North Eastern Regional Power Committee

Sub: Minutes of 60th Protection Coordination Sub-Committee (PCC) Meeting

60th Protection Coordination Sub-Committee Meeting

Date: 31/10/2023 (Tuesday)

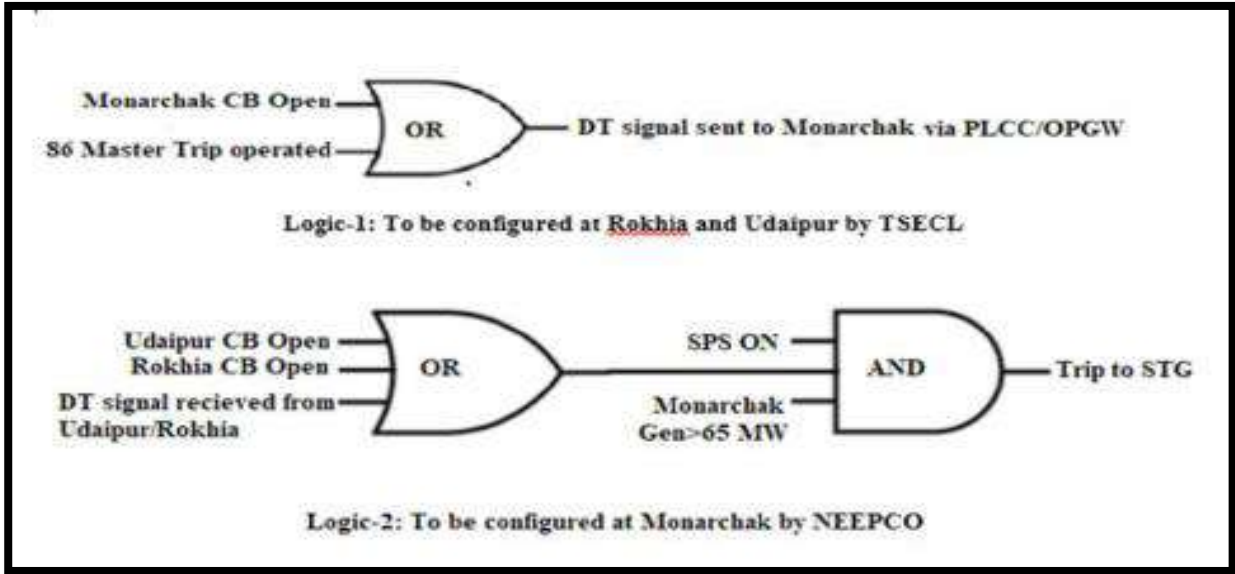
At 13:08 Hrs on 15-Sept-2023, 132 kV Monarchak - Rokhia Line tripped on DP with following relay indications- **Monarchak:** B-Ph, ZI, FD: 07.86 km, AR Successful, **Rokhia:** B-Ph, ZII, FD: 28.95 km. Non- operation of SPS at Monarchak is observed due to Successful autorecloser at Monarchak.

In the above event, Monarchak survived N-1 contingency as actual generation was 94 MW only otherwise blackout of Moanrchak is unavoidable.

Followings actions are requested from **TPGCL** and **NEEPCO**:-

- **NEEPCO** is requested to disable A/R operation at Monarchak for Udaipur and Rokhia line as a short-term measure to avoid blackout of Monarchak power station until implementation of PLCC/OPGW link by TSECL.
- **TPGCL & TSECL** is requested for early implementation/commissioning of PLCC link for successful operation of A/R scheme during transient fault at Rokhia and Udaipur. This will allow the changes in SPS at Monarchak :

B.14 Blackout of Karong S/S of Manipur on 10-10-2023:

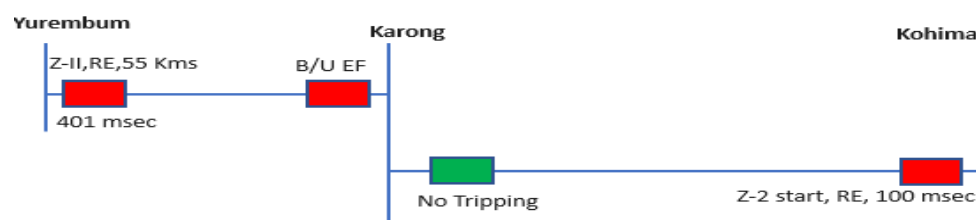
Blackout of Karong S/S occurred due to tripping of 132 kV Imphal – Karong Line & 132 kV Karong – Kohima Line at 12:21 Hrs of 10-10-2023.

MSPCL informed that some accident happened in the sub-station area. The same could not be timely intimated to NERLDC due to suspension of internet data connectivity in Manipur. Also, DR/EL of Karong could not be submitted due to no internet connectivity in Karong area. Manipur informed whitelisting of some of the contacts of Karong substation personnels will be done to facilitate timely submission of DR/EL of Karong.

Nagaland stated that relay settings are ok, however mal-operation could be due to phase angle mismatch, need to check both end phase angle once situation normalize in Manipur.

Nagaland was requested to share Main and Backup relay setting data with NERPC & NERLDC to check the relay setting issue. Forum requested Nagaland to disable B/U feature from main numerical relay as Standalone B/U protection is already available.

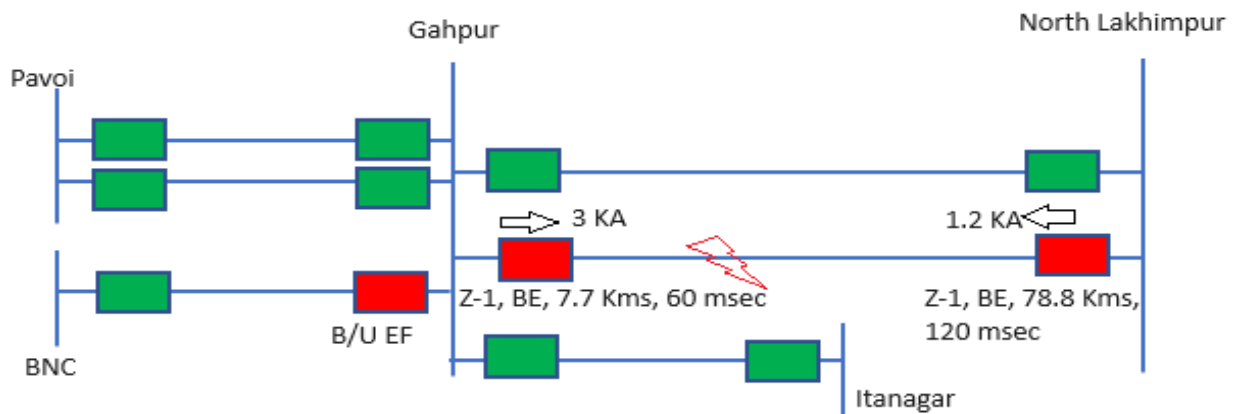
At 02:33 Hrs on 29-Sept-2023 both 132 kV Agartala- Monahpur Line & 132 kV Dhalabil - Mohanpur line tripped from the **Mohanpur end** on operation **Earth Fault** and **General Trip** which led to **blackout of Mohanpur Substation**. No tripping was observed from the other end such as Agartala & Dhalabil.

Root cause cannot be concluded due to non-submission of DR and EL by TPTL.

TPTL is requested to share the root cause of tripping and remedial measures taken.

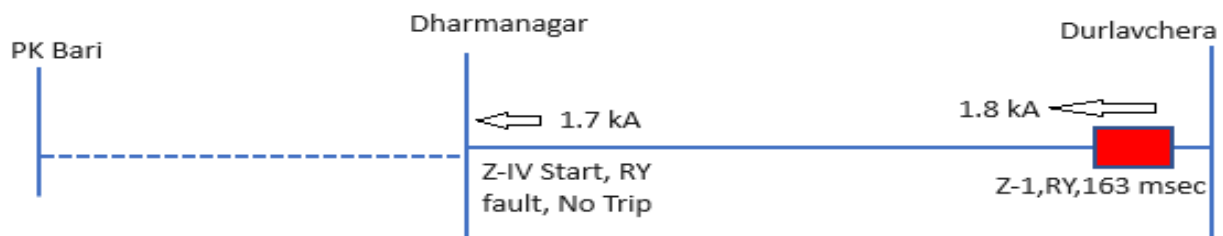
At the same time 132 kV BNC line tripped from Gohpur on dir B/U EF (421 A) within **40 msec** which inferred to be **UNWANTED**.

AEGCL is requested to intimate the root cause and remedial measures taken after the event.

AEGCL intimated that Backup E/F relay operated at BNC due to fault in reverse direction as Main-2 relay B-phase PT fuse blown resulted in improper prediction of directionality at BNC end. Fuse has been replaced by spare one. The necessary action for rectification will be taken soon.

Event-2(19-10-2023):

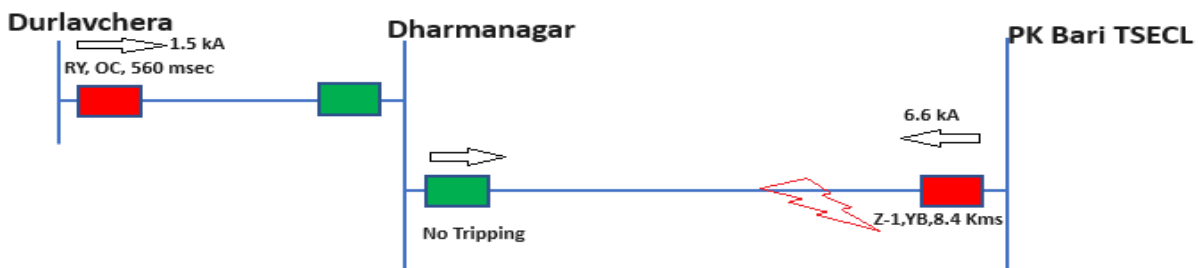
At 01:47 Hrs, 132 kV P K Bari -Dharmanagar Line and 132 kV Dharmanagar – Dullavchera Line tripped which led to blackout of Dharamanagar area of Tripura Power system. Load loss of **22 MW** recorded at Dharmanagar area of Tripura power system, which is the matter of concern.

Phase to Phase fault was in 132 kV PK bari-Dharmanagar Line and fault was cleared from PK Bari within 60 msec. Protection system at Dharmanagar **fails to isolate** the fault, due to which fault was feeding continuously from adjacent healthy Line 132 kV Durlavchera-Dharmanagar from Durlavcherra end and finally clear the fault within 560 msec on B/U O/C protection.

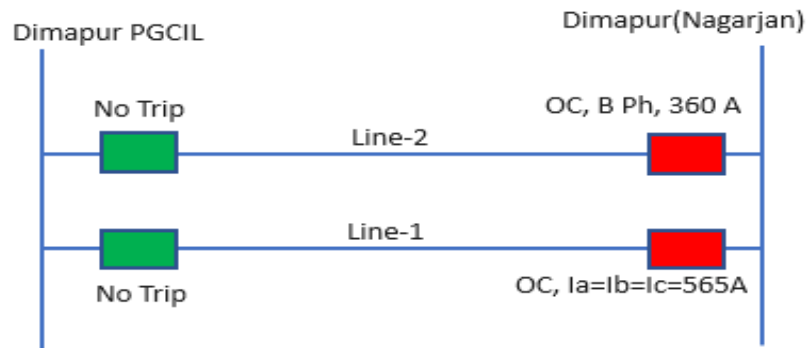
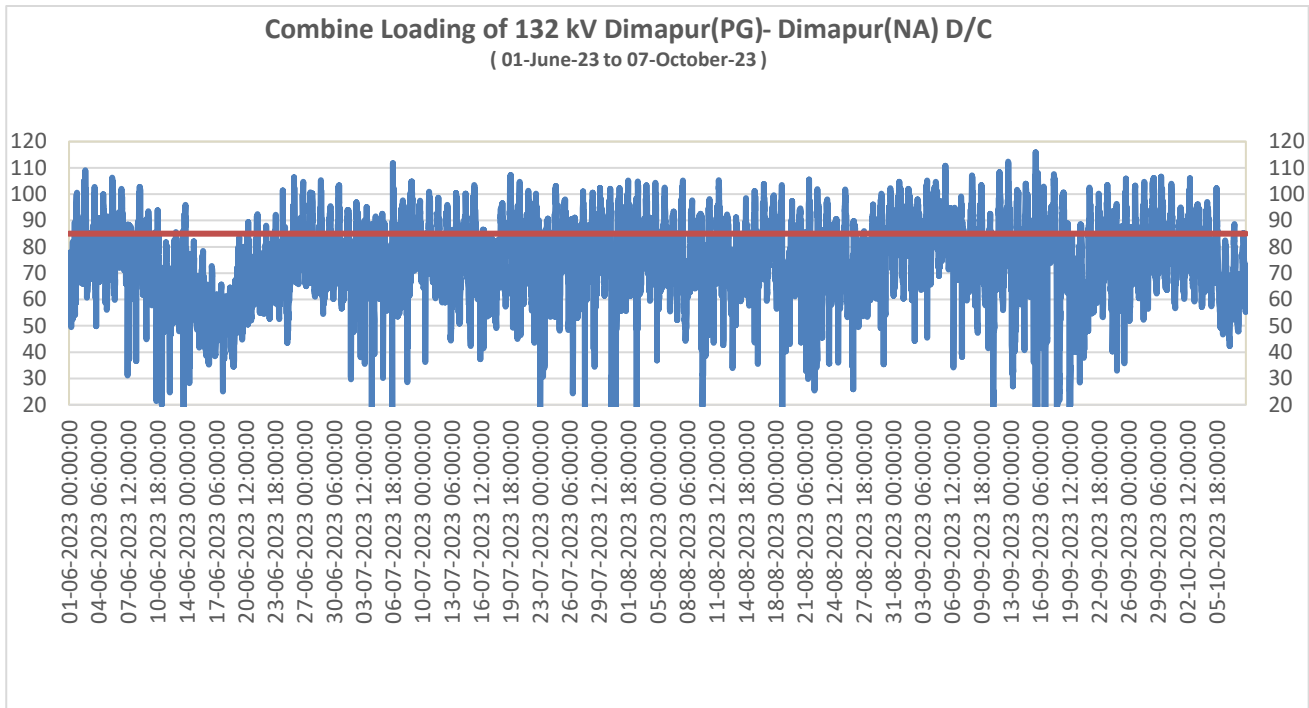
At 18:30 hrs of 15-09-2023 and 17:38 Hrs of 16-09-2023, 132 kV Dimapur (PG)-Dimapur (Nagarjan) D/C tripped leading to blackout of Dimapur (Nagarjan) area of Nagaland Power System, which is the matter of concern.

1. There is no fault in the system as per DR/PMU signal.
2. About **40A -50 A** less current observed in B-phase as compared to other R & Y phase in Line-1. This 50 A current is added to B-phase of parallel line-2 which led to tripping of Line-2 on over current. It seems that there is some issue with primary side connection, which may be due to loose jumper joints/isolator etc that creates high impedance path in B-phase of Line-1.

1. **DoP Nagaland** to carry out thermal scanning during loading condition.
2. **PGCIL** to carry out line impedance measurement test so that imbalance current issue may be known.

- DoP Nagaland to increase the Overcurrent relay setting to 420A (**91 MW**) or 70% of CT ratio as discussed in the 206th OCCM.

Forum requested DoP Nagaland to check tightness of each bay elements from gantry tower to CB at Nagarjan end.

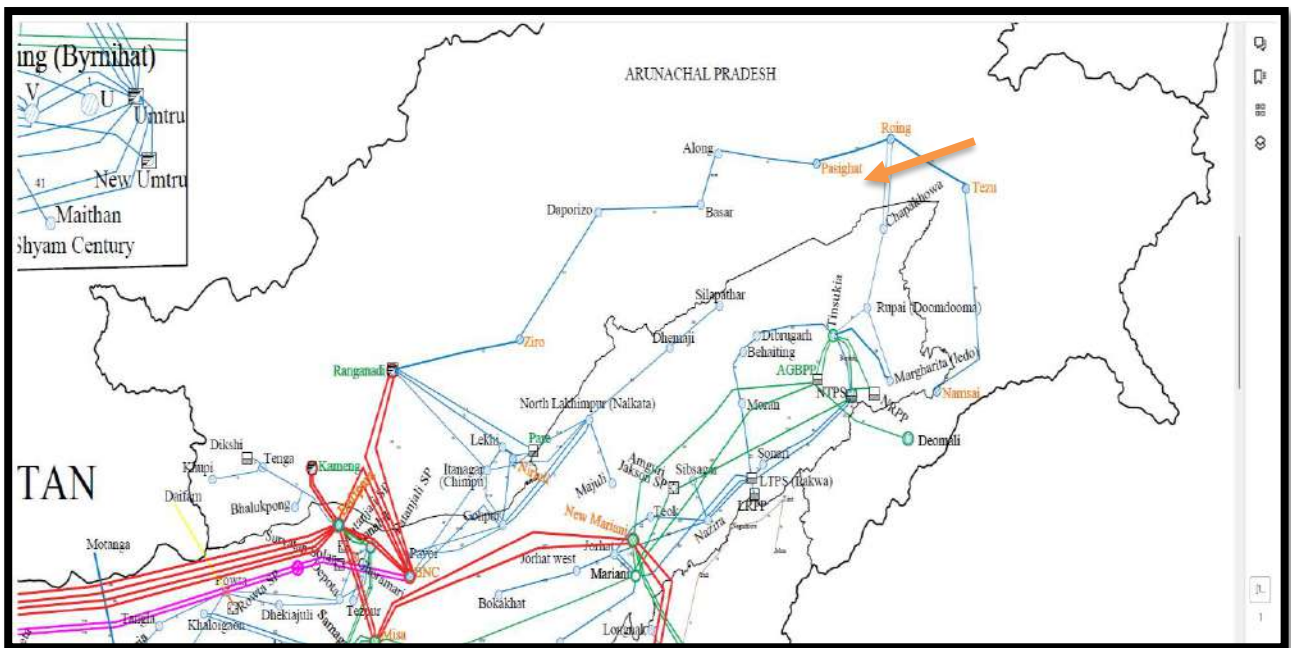
Hence, to satisfy the N-1 contingency at Dimapur (NL) and to avoid load loss in the Dimapur area, DoP, Nagaland is requested to implement suitable System Protection Scheme (SPS) with following criteria-

If the loading of any one circuit current exceeds more than 415A, the SPS will trigger and it will shed 25-30 MW load at Nagarjan area, which will increase the reliability of Nagarjan area of Nagaland system.

DoP Nagaland updated that reconductoring of the line is under process, DPR is in final stage.

A Single line diagram showing the connectivity of the 400 kV Palatana-Bongaigaon Transmission system is as follows:

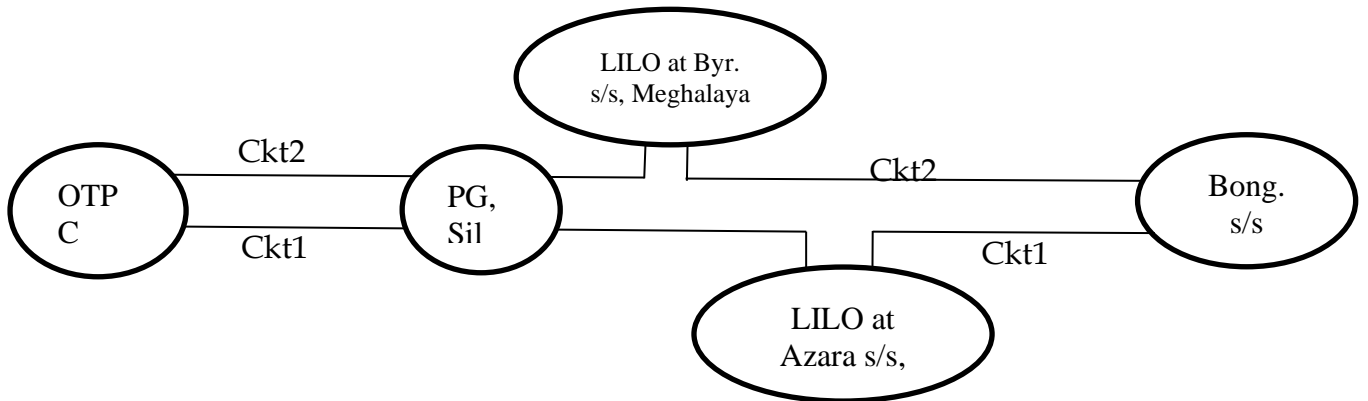
During the last financial year (FY 2022-23), there were instances of tripping in the 400 kV D/C Palatana-Bongaigaon Transmission System. Due to inaccurate fault calculations of the relays, difficulties were faced in detection of fault location. In normal scenarios, we expect to locate the faults within a range of +/- 5 km from the relay distance measurement. However, during post-fault patrolling, we discovered fault locations approximately 10-15 km away from the relay's calculated distance. The same issue persisted for the tripping instances during the current Financial Year (2023-24) as well. Here is a brief overview of such tripping instances:

In view of above, we propose the following for detail deliberation by the forum:

- i) A comprehensive review of the relay setting arrangements and implementation of the modified setting in conformity with the actual line parameters at all the connecting substations.

Fig: SPS Schematics at 132kV Khliehriat S/S for 132kV PG Line I & II

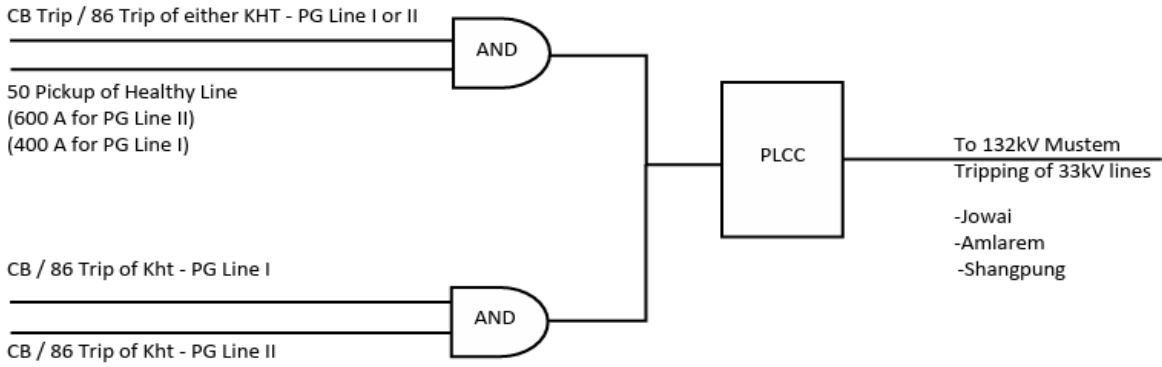
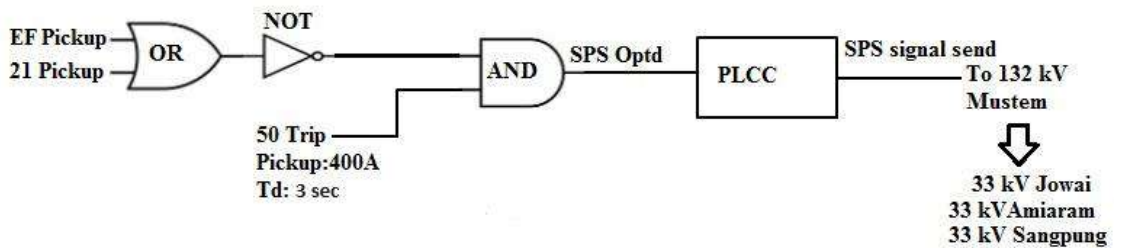
The above requirement was agreed in principle during the 205th OCC meeting and NERLDC and MePTCL were requested to develop the tripping logic and to present it in the next PCC meeting. The schematics of the SPS is attached for reference.

NERLDC provided the modified logic (as below) and same need to be implemented by MePTCL. MePTCL agreed the same.
